# HISTORIC LANDMARK COMMISSION APRIL 25, 2016 DEMOLITION AND RELOCATION PERMITS HDP-2016-0230 1105 S. LAMAR BOULEVARD

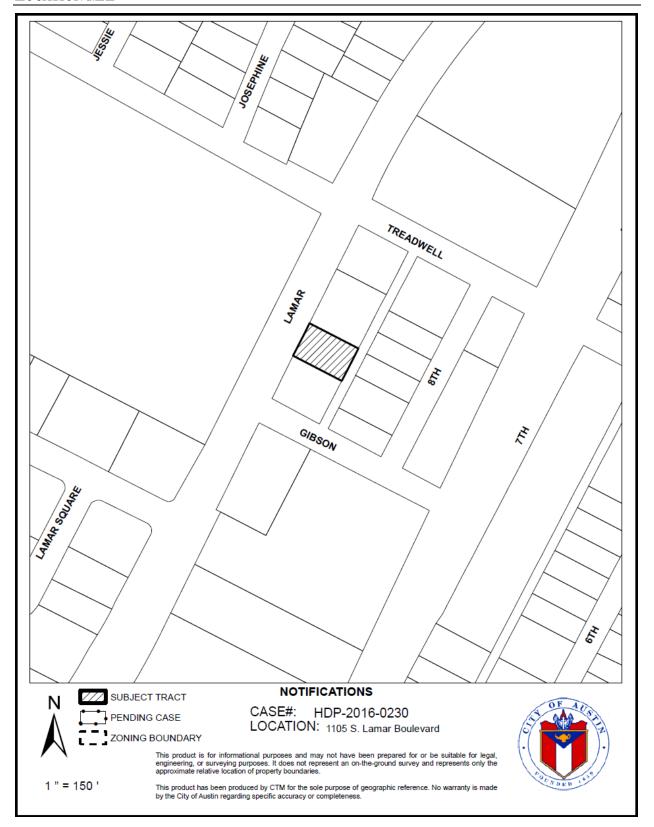
The applicant seeks to convert this stone house from a title loan office to a coffee shop by constructing a 150-square foot addition to the back of the house for a walk-in cooler and storage. The proposed addition will have horizontal wood siding to match wood siding on the house. Two wood decks will be constructed in the front yard under the trees. The existing windows will be rehabilitated, and the existing wood ramp will be updated to meet current standards. The existing metal roof will be patched and repaired. At the rear of the house, an existing door and staircase in a non-historic rear frame addition will be removed, and one exterior window from the rear of the house will be relocated to the location of a probably non-historic door on the porch. The location of the window to be removed will be enlarged into a doorway for access to the proposed addition, and the stone from that location will be placed under the relocated window on the porch.

Approve as proposed. The applicant's proposal is very sensitive to the historic character of the house and its historic fabric. The door proposed for removal on the back of the house is in a frame addition, not the stone house, and the window proposed for relocation will be placed on the side of the front porch where it appears there was once a window rather than the current door.
